# Access Compliance Report

## Public Rights-of-Way

### (Curb Ramps)

Intersection ID: 13247	Main Street: MERRIMAN_AV	Cross Street: W_KINGSTON_AV	Location: E
ADA ID: FB6D92B8ECDD	Ramp Type: ParaDiag	Initial Pass/Fail: Fail	Overall Compliance: No
			Severity Score: 26.25

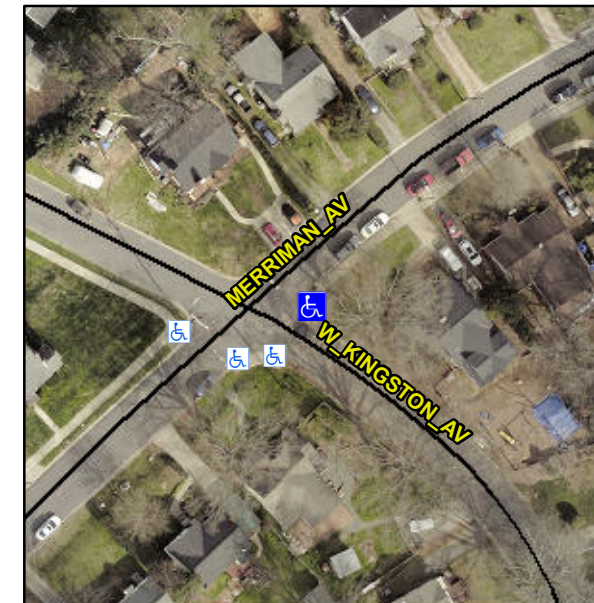
**Remove & Replace Curb Ramp With Two New Directional Ramps or Equivalent.**

**R304.3.2, R304.5.3**
